Office Action Summary

10/629,715

KIM ET AL.

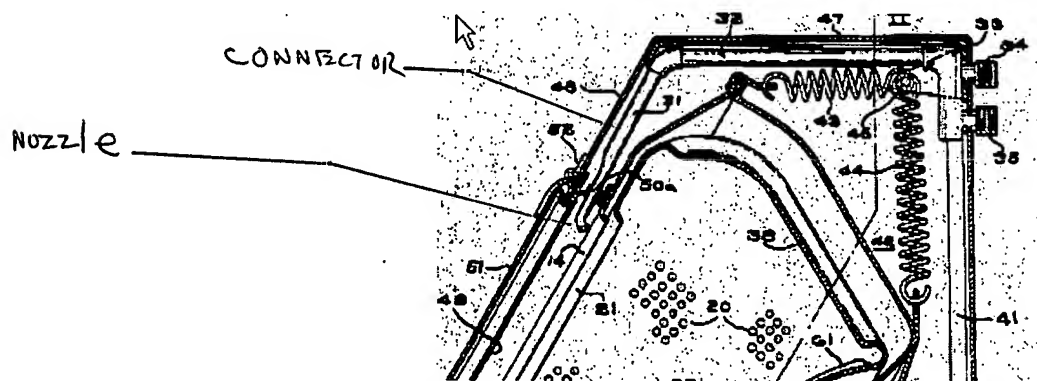
a circulation motor (as at circulating pump 57) that pumps the water in the outer tub, wherein the circulation motor communicates with a lower side of the outer tub;

a circulation hose (unnumbered, see fig. 7. above) that guides the pumped water, wherein one end of the circulation hose is connected with the circulation motor;

a gasket (46, col. 11 line 16) that prevents water leakage into the cabinet; and
an injection unit comprising:

a connector (unnumbered, see notation in fig. 7 above), wherein a first end of the connector is connected to the circulation hose and a second end of the connector penetrates the gasket, and
a nozzle (59) positioned below the gasket, wherein the nozzle is configured such that water is dispersed into the inner tub that differs from the claims only in the recitation of the water being specifically dispersed in a plurality of substantially horizontal directions
